W-REF: P16-335  
25 March 2020

## Response to Auckland Council Further Information Request on Stormwater Matters for Drury East

This memo has been written to summarise the additional stormwater assessments undertaken in response to the Further Information Request (FIR) from Auckland Council for the Drury East Plan Change requests.

Figure 1: Flow comparison – 10yr

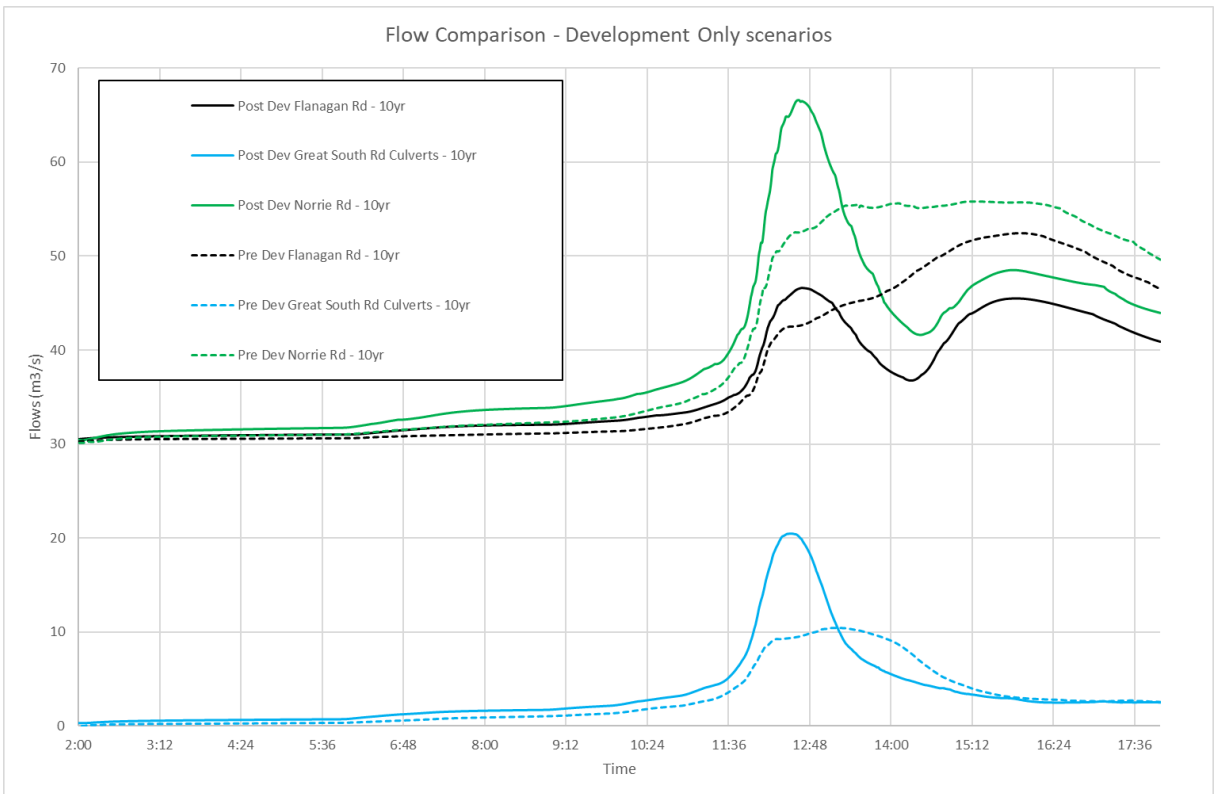
Flows were extracted for the 10yr and 100yr scenarios to understand the differences between the pre and post development scenarios for the 'Development only'. The post development flows are peakier when compared to the pre-development scenario but have shorter time to peak with no lag as seen in Figure 1 and 2 below.

Figure 3: 10yr Flow comparison

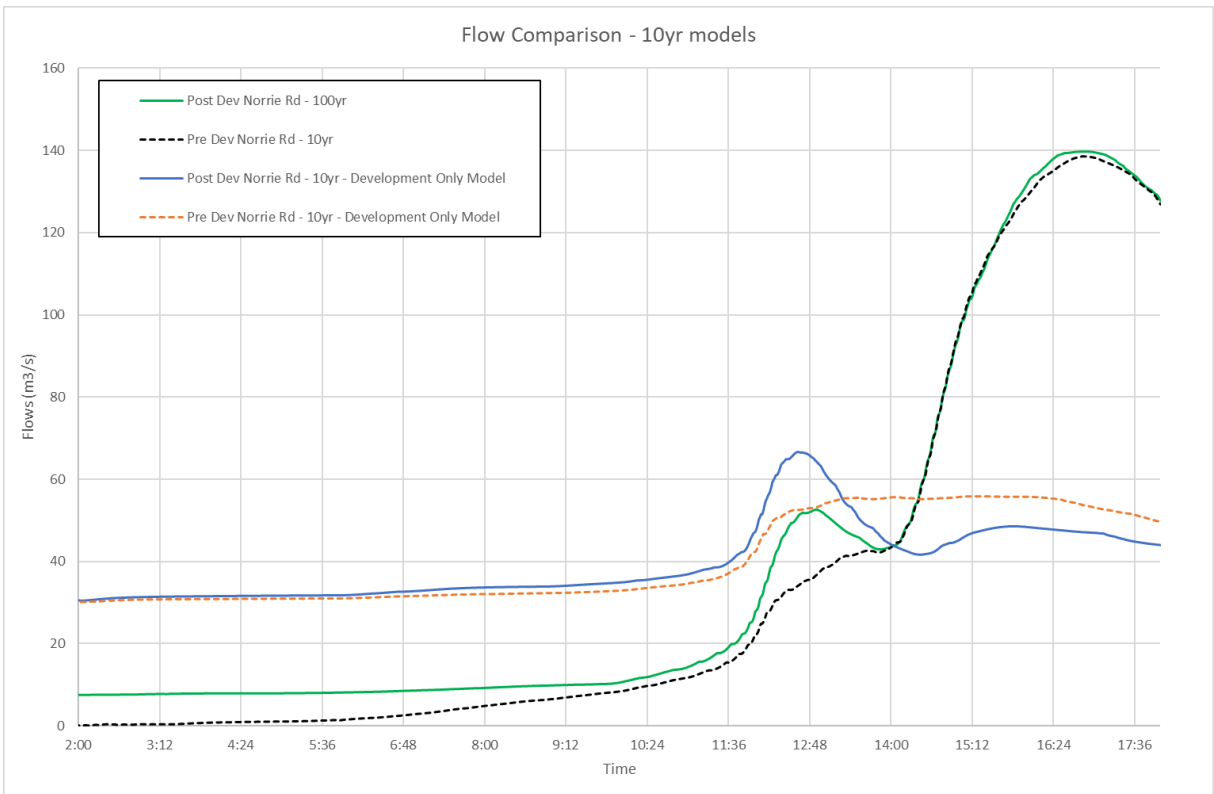
The 10yr flows at Norrie Road bridge were compared for the catchment and 'Development only' models flows which confirm that a 'pass flows' forward approach works better for the proposed development to discharge majority of the flows before the peak of the upstream flows reach Drury township.

This is supported by the building floor risk analysis which shows no increased flood risk to buildings/habitable floors with the 'pass flows forward' approach.

Pre Development 2 Year MPD Flood  
Assessment  
Catchment Model  
Climate Change - YES

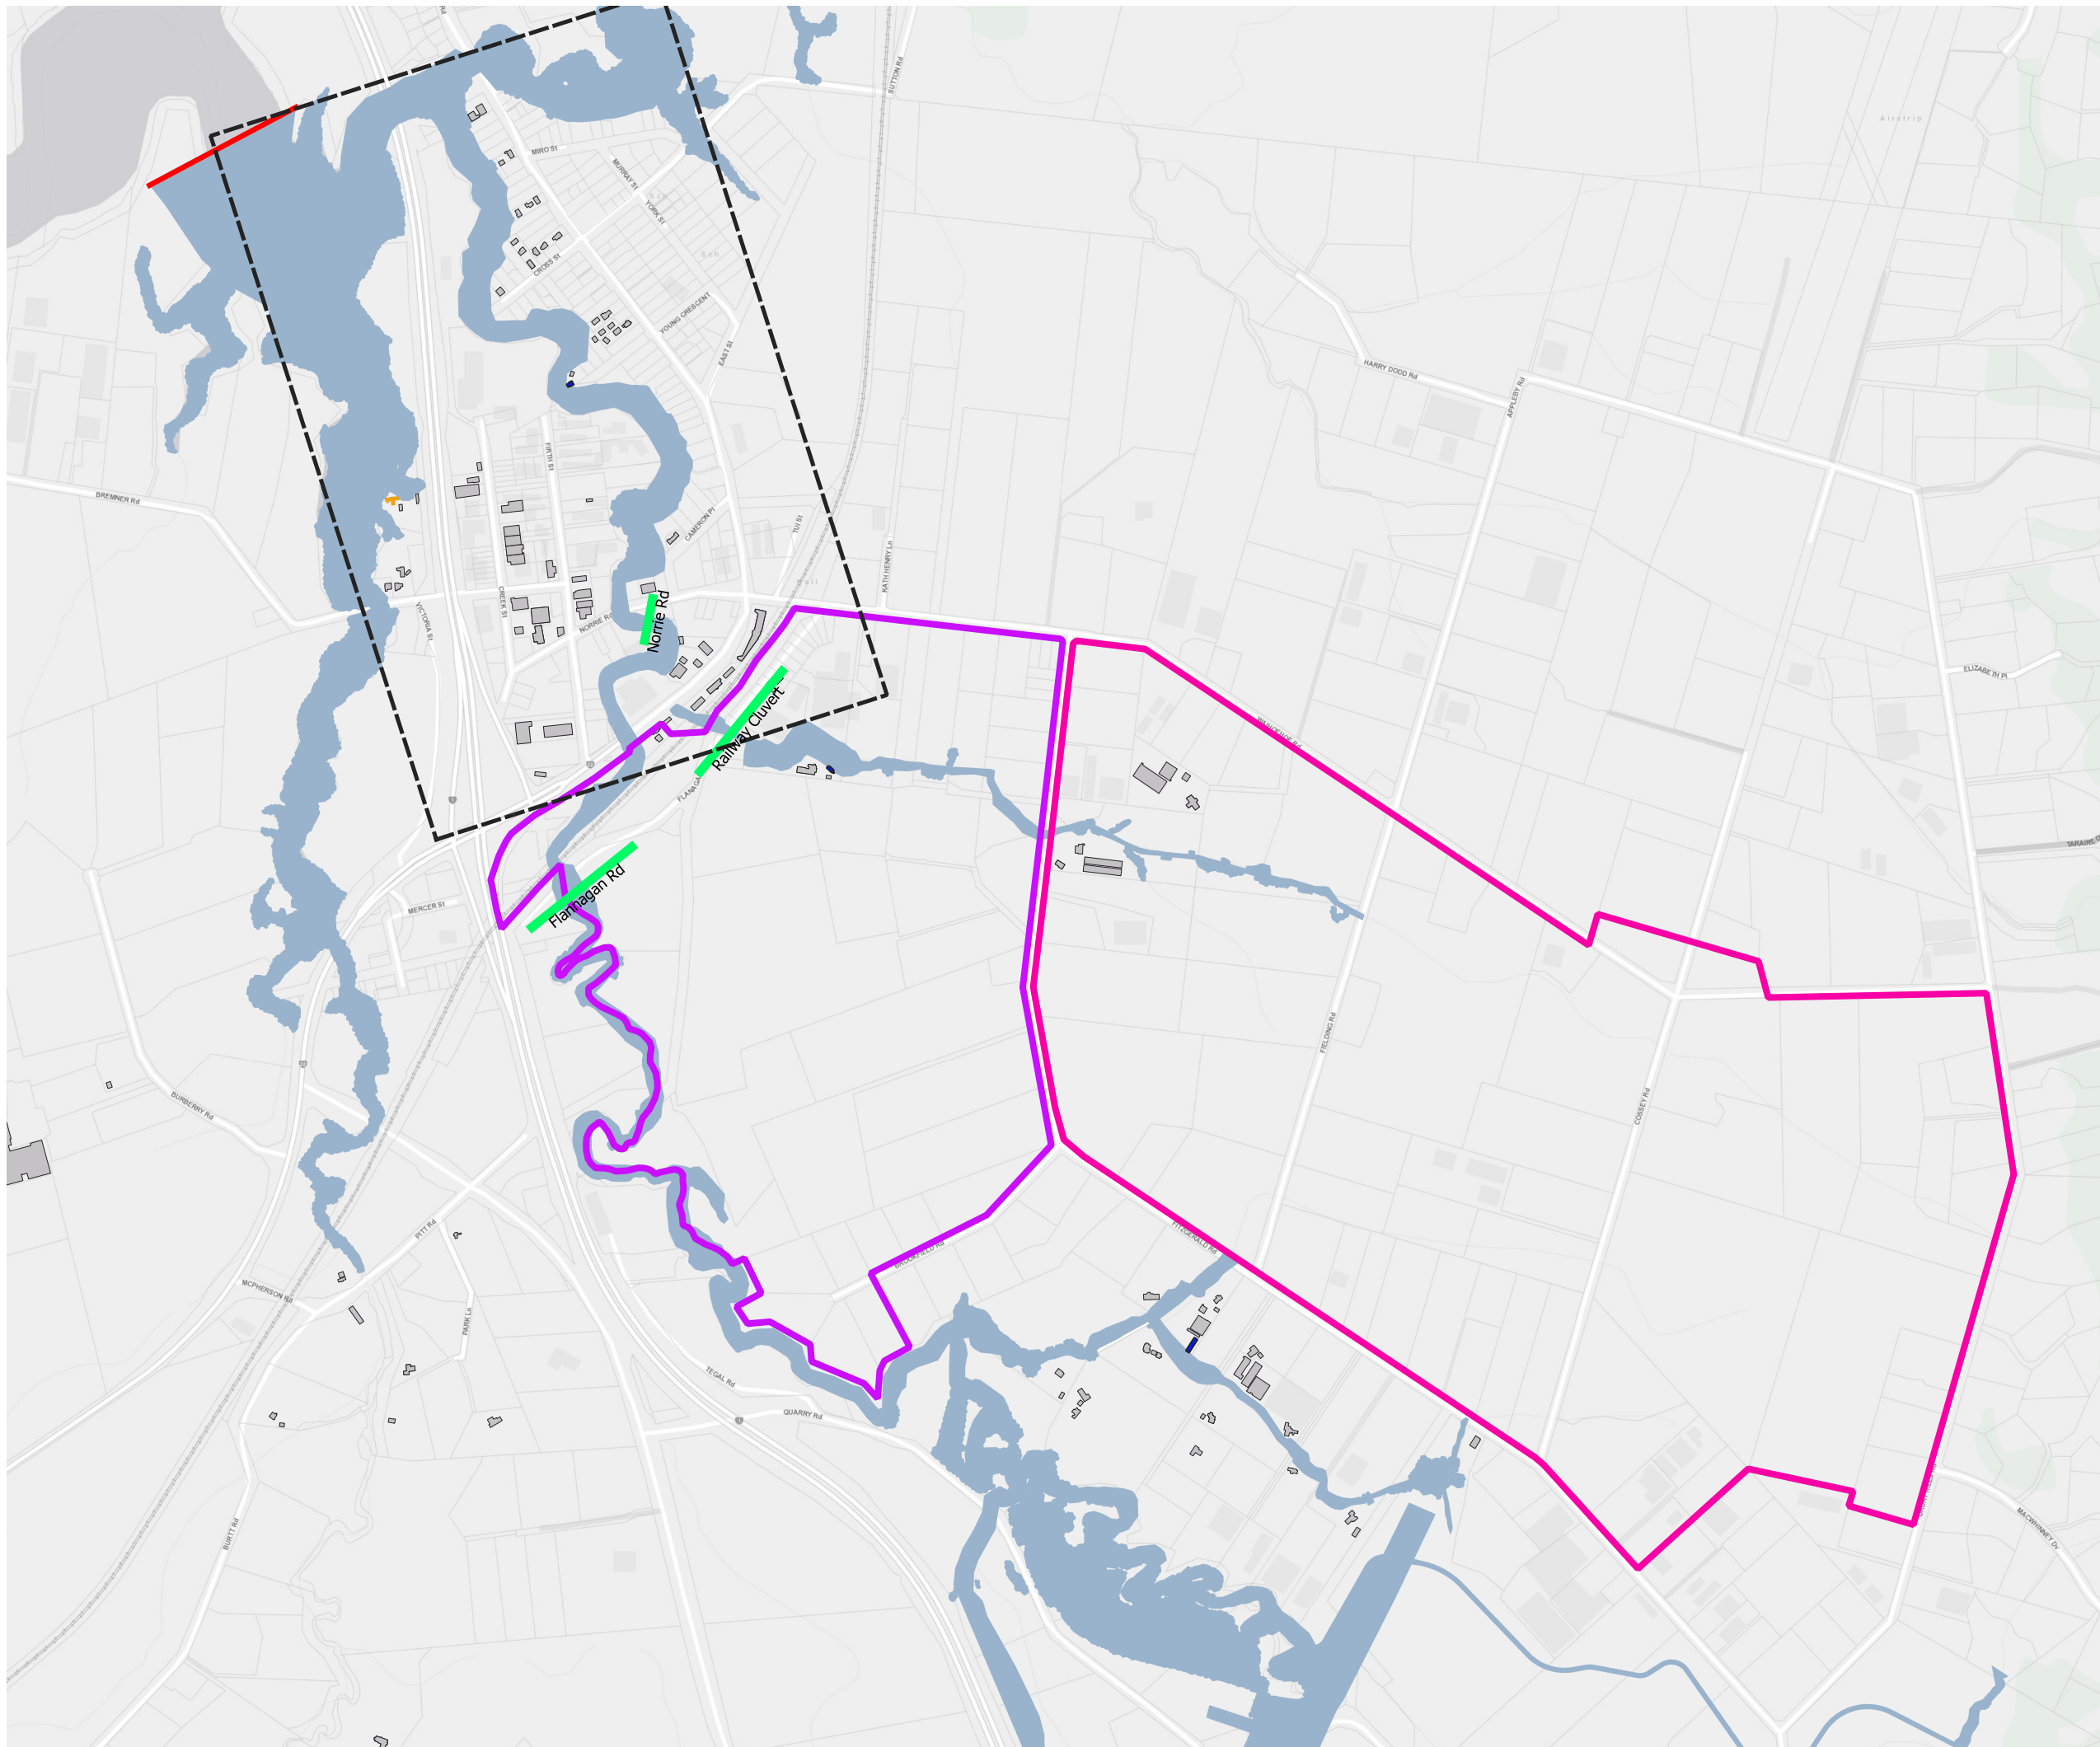
05	Flooding	<p>Please address the matters identified and discussed in the memo to Healthy Waters from Tonkin and Taylor dated 19 Feb 2020.</p> <p>We note that all applicants need to explain what the effect cumulatively across developments will be on the Drury township flooding and parts of the catchment that interact with the Slippery Creek floodplain.</p>	<p>Flooding in the Hingaia catchment is complex and needs to be considered in conjunction with other plan changes proposed for the area; acknowledge any interactions with other catchments and the cumulative impact of potential development in the surrounding areas and the point of discharge downstream. Understanding the impact of development on the flood plain within the plan change sites and impacts downstream is necessary to evaluate the plan change proposal and ensure any potential flood effects are avoided or mitigated.</p> <p>Several discussions between Healthy Waters and the applicant's planners have occurred on the best way to approach flood</p>	Refer to Section 3: Flooding of Memo P16-335.

The intention of this assessment was to understand if there is any increase in flood risk to properties downstream of the Plan Change Areas with the increases in flows associated with higher imperviousness within these developments. This area of analysis is shown in figures (provided in Appendix B) and all flood results outside this extent as less reliable with the model setup.

The analysis shows that the total number of properties flooded are unchanged, for the 'Development only' as well as Catchment models for the scenarios analysed. This confirms there is no additional flood risk to habitable floor or properties with the proposed development in place.
